**DEFENSE NUCLEAR FACILITIES
SAFETY BOARD**

March 25, 2015

Staff Issue Report

SUBJECT: Aerosol Entrainment Coefficient Based on Testing and Data Analyses for the Waste Treatment and Immobilization Plant

Figure 1: Entrainment coefficient above bubbling or boiling water pools containing non-soluble solid particulate material. The x-axis is concentration of solids in the simulant. The solid line is the FAI-recommended AEC value [8].

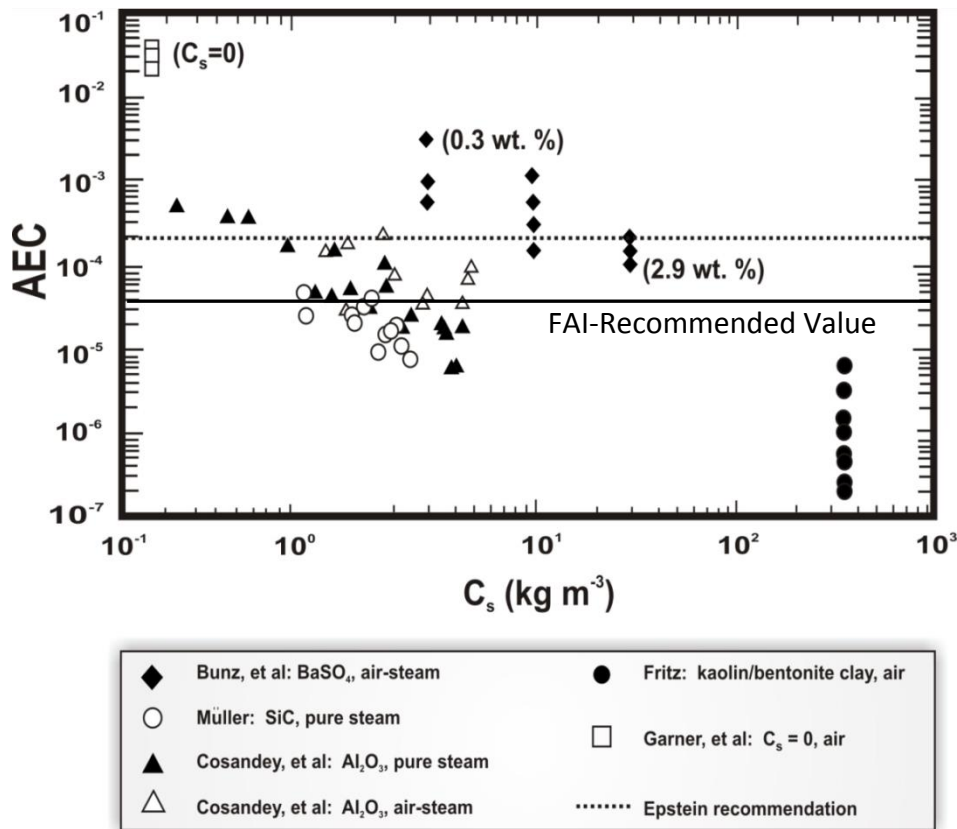
Range of Simulant Properties—The ranges of physical and rheological properties of the small-scale testing simulants are listed in Table 1. These bound the properties of the medium-scale testing simulants. For comparison, the expected ranges of physical and rheological properties of the non-Newtonian waste in WTP process vessels are also listed in Table 1. The properties of the small-scale and medium-scale test simulants did not span the range of properties (i.e., particle size distribution, viscosity, Bingham yield stress) expected in the WTP waste. The Board's staff team questioned this testing approach during the October 2012 video-teleconference. The project's outside experts from FAI stated that AEC values plateau to low, constant values when enough contaminants (e.g., salts, undissolved solids) are present and, therefore, parametric testing to span the full range of WTP properties is not necessary. The basis for this assertion was later captured in a graph generated by the author of the FAI report (as shown in Figure 1). The staff team examined the graph, but could not conclude that the AEC values plateau to a low, constant value with increasing concentration of solids. For example, the graph shows that for a given concentration of solids, the AEC values can vary more than one order of magnitude. The staff team concludes that the provided graph does not support the previous assertion. As a result, the staff team was not able to conclude that the testing conservatively predicts the aerosol challenge to the WTP ventilation systems.

Composition of Solids in Aerosols—The test simulant contained large particles, e.g., 50 volume percent of the simulant solids had a diameter (d_{50}) greater than 23.5 μm . Parsons stated that solid particles with diameters over 20 μm are not expected to be suspended in aerosols and, therefore, to impact the AEC value [10]. However, to convert raw test data to an AEC value, Parsons’ calculations assumed that the composition of aerosols on the filter media was identical to

the composition of the bulk slurry in the test vessel. Given Parsons' methodology and reasoning, simulants with a larger d_{50} will produce smaller AEC values. But non-Newtonian waste at WTP may have d_{50} values as low as $0.3 \mu\text{m}$ (see Table 1). The Board's staff team is concerned that Parsons' choice of simulant, together with the assumption of equal aerosol and test slurry compositions, result in non-conservative AEC values.

Figure 2. Recommended AEC values in relation to all small- and medium-scale test data analyzed as a function of sparger pressure difference (dP).

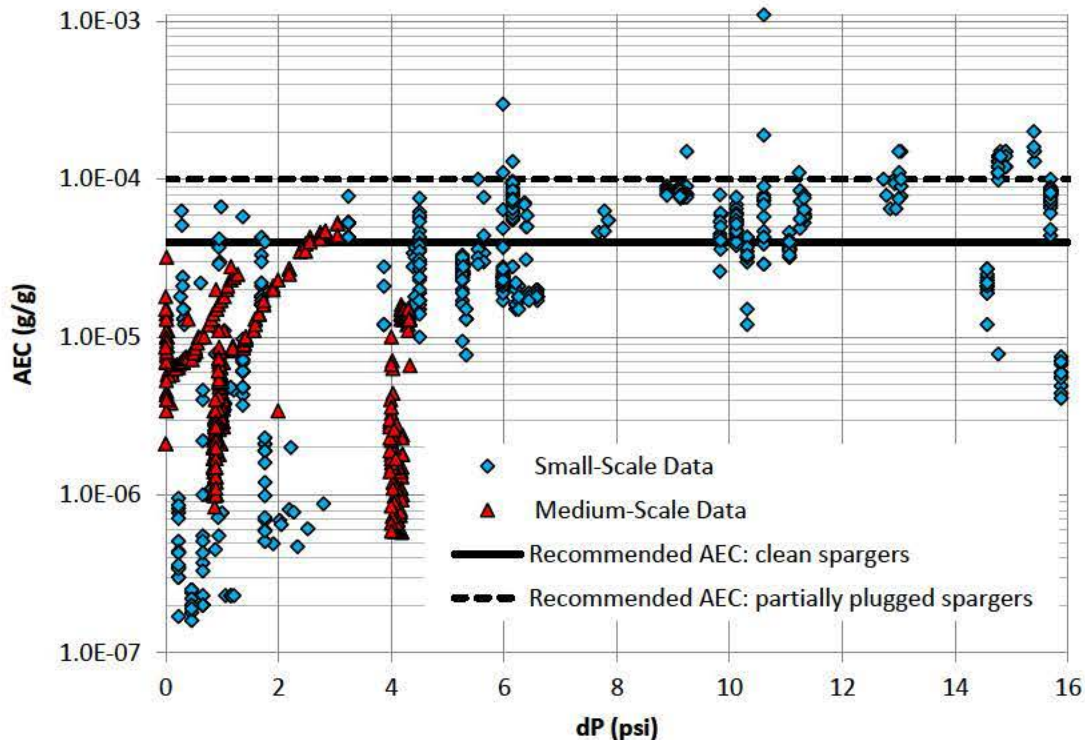
- The largest values of AEC measured in the small-scale tests exceeded 1.0×10^{-3} , and the medium-scale test values exceeded 5.0×10^{-5} . Using arguments regarding enhanced aerosol production and entrainment in the small-scale tests, FAI based the recommended AEC value for WTP on the medium-scale test data. FAI examined the medium-scale test data and concluded plugging of the sparge tubes and gas jetting was also present in some tests and contributed to elevated values of AEC. FAI recommended two bounding values for the AEC:

Figure 2 shows these two recommended values of AEC in relation to all the small- and medium-scale test data [8].

Figure 3. Conceptual model for natural convection in headspace

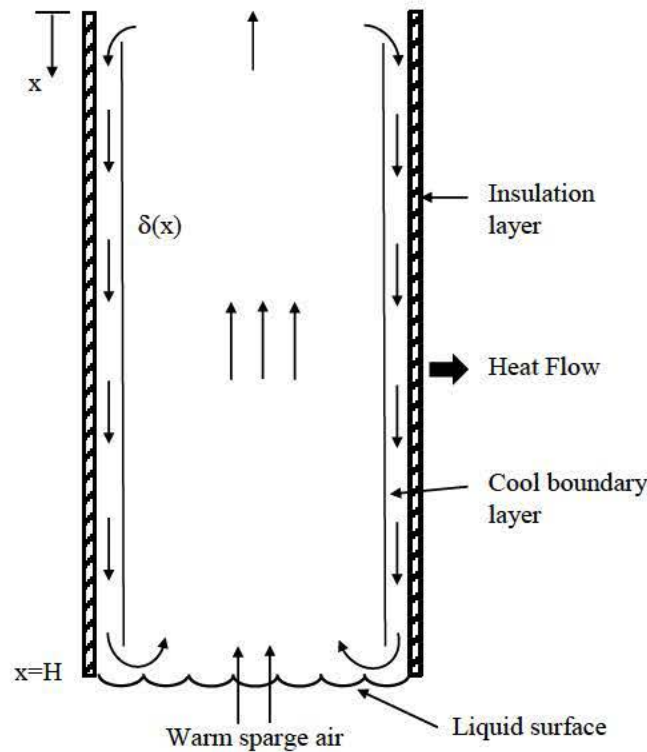
The Board’s staff team examined the FAI report’s model and equations for natural convection in the small-scale tank. The model assumes natural convection in the small-scale tank is driven by a temperature difference between the cooler wall of the vessel and the warmer headspace atmosphere, which results in a downward flow along the wall of the vessel. FAI’s proposed flow pattern within the small-scale tank is given in Figure 3 below. The boundary layer shown in the

figure is the zone of downward flowing cold air adjacent to the tank wall. The natural convection model solves for both the boundary layer thickness and downward flow rate at the wall. The downward flow at the tank wall was converted to an upward velocity in the headspace through an area relationship that neglects the area contained within the boundary layer. The magnitude of the upward velocity due to natural convection was compared with the magnitude of the sparge-induced upward velocity and found to exceed it by about a factor of three. The report concludes that natural convection artificially increased the droplet vertical transport, resulting in artificially high values of AEC.

The analysis presented in the report implicitly assumes that the boundary layer is very thin compared to the diameter of the tank. Specifically, the report estimates the boundary layer thickness along the wall of the tank using an equation for a vertical plate, an approach that is generally valid when the boundary layer thickness is much less than the tank diameter. The Board’s staff team calculated the boundary layer thickness in the small-scale test tank using the equations given in the report and found that the boundary layer grows rapidly to exceed the tank radius. Because the key modeling assumption of a thin boundary layer is not supported by the model results, the conclusion in the FAI report that enhanced entrainment is due to natural convection in the small-scale test tank is not supported by the analysis.

is not defensible. The staff team concludes a more realistic analysis of natural convection utilizing a computational thermal-fluid model would be required to determine the role of natural convection in both test vessels and plant vessels.

Figure 4. Sparger nozzle velocity relative to the critical velocity for jetting for the small-scale test data based on jetting model [8]. Also shown is the pressure drop corresponding to the “jump” in AEC data claimed in the FAI report.

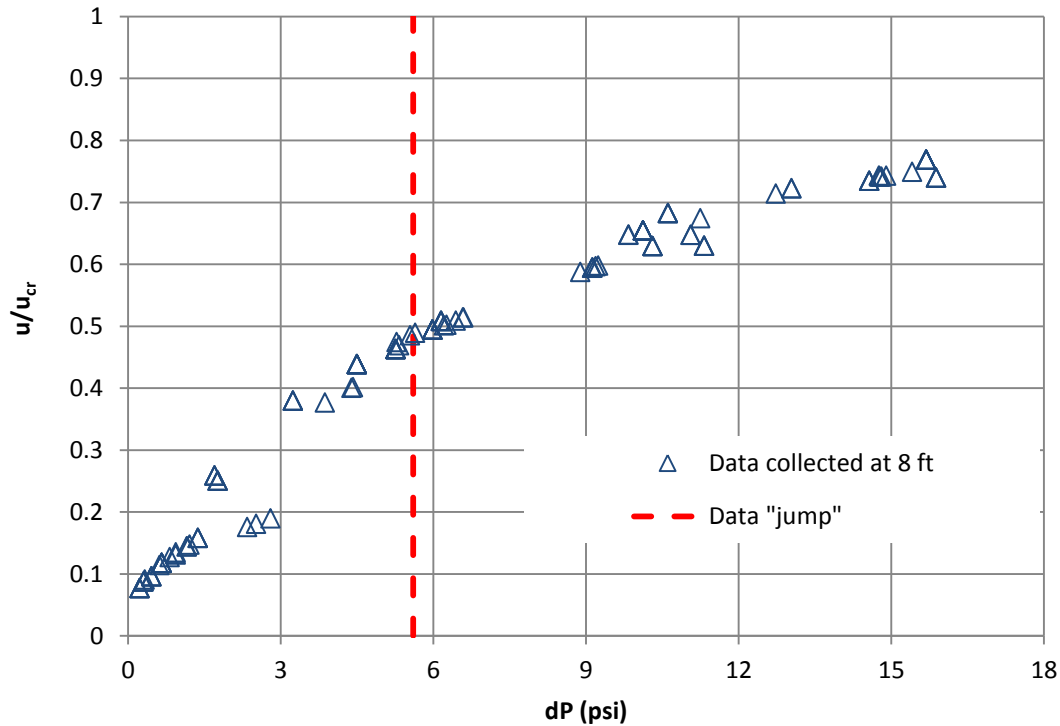
The Board’s staff team independently analyzed whether the data “jump” at 5.6 psi claimed in the report was meaningful and not an artifact of data noise or some other phenomena. The staff team attempted to validate the report’s conclusion by evaluating the data collected at all elevations and found that, while there was some discernable increase in AEC for pressure drops in the range of 5–6 psi, it was a statistically insignificant local feature of the data, and no general trend can be established.

The staff team also found that the pressure drop criterion for sparge jetting presented in the report was conceptually flawed and inconsistent with the model presented in the report. For example, when a plug begins to form, the effective diameter of the sparger orifice is reduced, resulting in an increase in both critical velocity and pressure drop. Using the model equations presented in the FAI report, together with the test data, the staff team calculated the average sparge nozzle velocity and the predicted critical velocity for jetting for all of the small-scale tests. Figure 4 below shows the ratio of these two velocities plotted versus measured pressure drop. The staff team determined that the average nozzle velocity was less than the critical velocity for jetting for all test points. This means that, according to the jetting model presented in the report, when numerically evaluated, the critical pressure drop for jetting was always found to be higher than the measured pressure drop. Therefore, according to the report’s criteria, no jetting was present in any of the tests. Further, the staff team repeated the evaluation for the results of the medium-scale test data and found that, based on the report’s model, sparger jetting was present in all but one test series. This is inconsistent with the report’s claim that only two of the medium-scale test cases exhibited sparger plugging.

Based on these findings, the Board’s staff team concluded that the proposed jetting model does not adequately reflect the data collected. Consequently, this model does not provide an adequate technical justification for asserting that small-scale testing experienced enhanced AECs due to gas jetting. Moreover, the model does not provide an adequate technical justification that the medium-scale data only experienced enhanced AECs due to jetting in two specific cases.
